## IMPORTANT SAFETY RECALL

**Safety Notice****SN-658**

SUBJECT: *GFI circuit breakers on 408 volt Hy-Power<sup>™</sup> units***Issue:**

Figure A

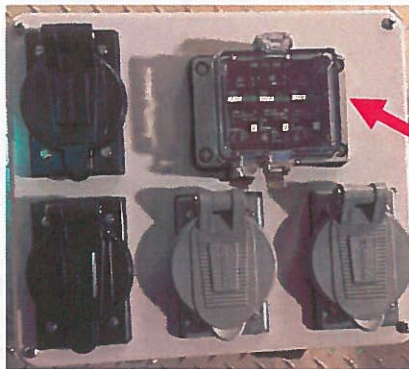
1. Immediately inspect your unit by locating the export power box as shown in Figure A and inspect the circuit breakers as shown in Figure B to determine the manufacturer of the circuit breakers. Only export power boxes that contain **CBi** manufactured circuit breakers are subject to this bulletin and must be replaced.

1. Do not use the export power supply, shown in Figure A, until the GFI is inspected and replaced as necessary.
2. Open breakers shown in Figure B and Lock-Out-Tag-Out the affected export power box circuit breaker cover per your company's procedure.
3. Follow all maintenance and inspection requirements specified in the manuals.
